OXFORDSHIRE COUNTY COUNCIL'S RESPONSE TO CONSULTATION ON THE FOLLOWING DEVELOPMENT PROPOSAL

Application no: 21/02083/REM

Proposal: Reserved matters application to 18/00792/OUT - for the demolition of existing buildings and erection of up to 46 no. dwellings, with associated works and provision of open spaces

Location: Land at Tappers Farm, Oxford Road, Bodicote, Banbury

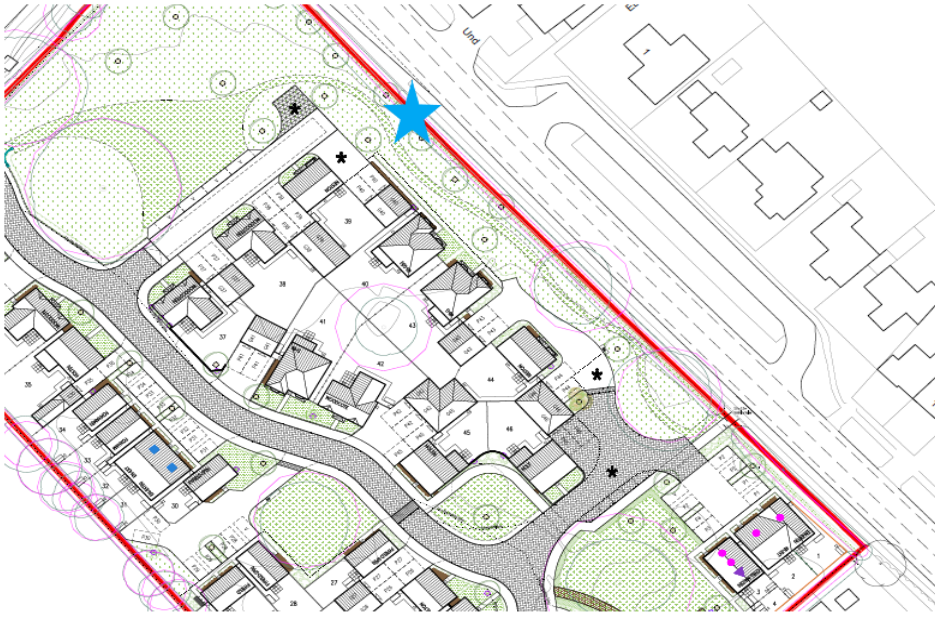
The S106 agreement secured from the outline permission sets out that, as part of the highway works package, two footway connections between Oxford Road and the development site would be provided to ensure that the development was suitably permeable and convenient for pedestrian access. This was based on two proposed pedestrian access points onto Oxford Road set out in the Illustrative Masterplan.

However, the detailed Planning Layout submitted with this Reserved Matters application only shows one such connection between the site and Oxford Road, just north of plots 1 and 2. In order to connect with the S106 secured highway works and create a convenient connection to Oxford Road for those living towards the northern end of the site, an additional footpath and connection point must be provided in a similar location to that shown in the original Illustrative Masterplan, roughly in the location of the blue star shown on the image below:

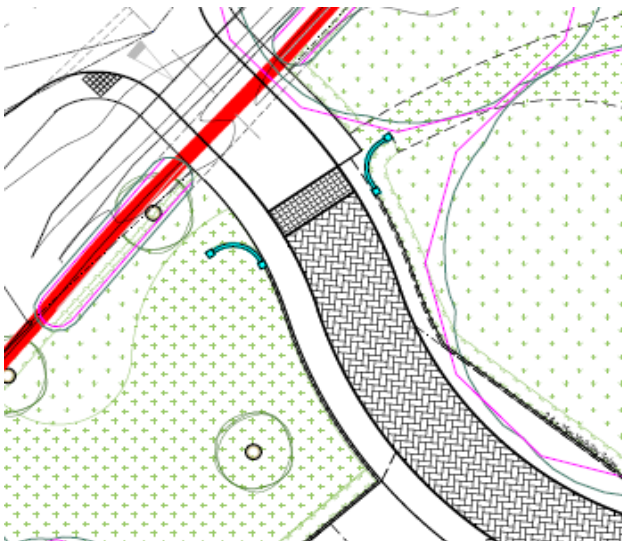
It is unclear why the footway on the eastern side of the access road narrows to c.1m shortly after entering the site, however this is substandard and does not enable those with mobility problems, walking aids or those with pushchairs etc. to easily pass other pedestrians without one stepping into the carriageway. With a new development such as this, the 2m wide footway along the access road must be consistent throughout the development, as it is beyond this point.
